PLANNED UNIT DEVELOPMENT

STAFF REPORT Date: May 21, 2015

DEVELOPMENT NAME Richardson, Inc.

CONTEMPLATED USE Planned Unit Development Approval to amend a

SITE PLAN

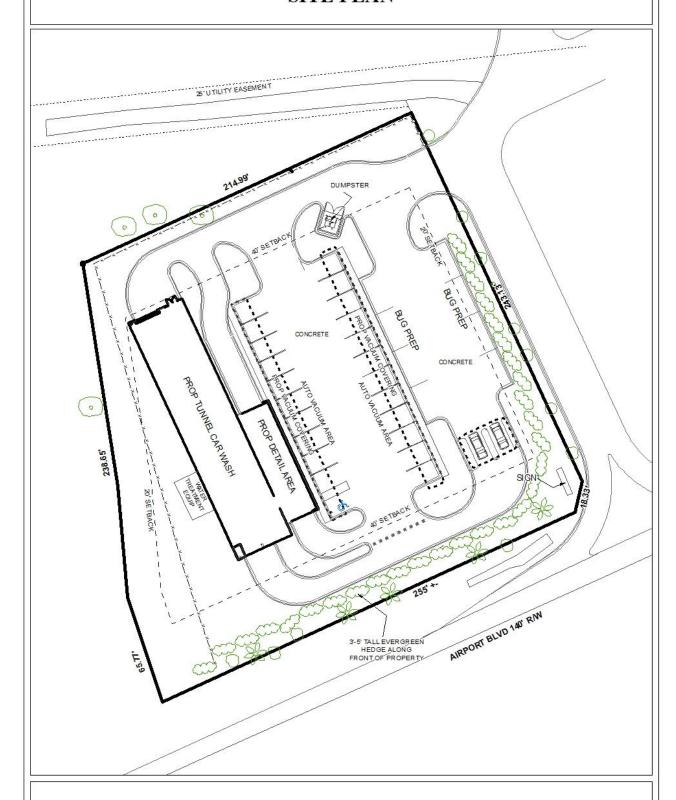
COMMENTS On-site signage will be required to direct traffic into the site on the left side of the driveway as opposed to the typical right side, due to the proposed circulation illustrated on the site plan.

Parking lot lighting will be required as a result of the new parking spaces. Any new lighting on the site must comply with the requirements of Sections 64-4.A.2., 64-6.A.3.c., and 64-6.A.8. of the Zoning Ordinance, and a note reflecting this requirement should appear on any revised site plan. Photometric plans will be required at the time of permitting for land disturbance.

In regards to trees and landscaping, compliant landscaping data and a 3' high evergreen hedge are depicted on the site plan. It is important to note that the site plan incorrectly depicts the southern lot line adjacent to Airport Boulevard a distance of 1,268.10'. The revised PUD site plan should depict a distance closer to 270'.

A dumpster is illustrated on the site in compliance with Section 64-4.D.9. of the Zoning Ordinance, to include a connection to sanitary sewer. A 6' high wooden privacy fence is also illustrated along the western and northern property lines; however, the site plan should be revised to depict all proposed fencing not to exceed 3' in height within the 25' minimum building setback along Airport Boulevard.

- 1) Revision of the site plan to depict the correct distance of the southern lot line, adjacent to the Airport Boulevard right-of-way;
- 2) Placement of a note on the site plan stating any new lighting on the site will have to comply with the requirements of Sections 64-4.A.2., 64-6.A.3.c., and 64-6.A.8. of the Zoning Ordinance. Photometric plans will be required at the time of land disturbance;

- 3) Placement of a note on the site plan stating that proposed privacy fencing is not to exceed 3' in height within the 25' minimum building setback along Airport Boulevard;

- 8) Submission of an approved, revised PUD site plan prior to the issuance of a Land Disturbance Permit;
- 9) Development limited to the revised site plan, future development of Lots 1 and 4 will require new PUD applications to amend the existing PUD; and
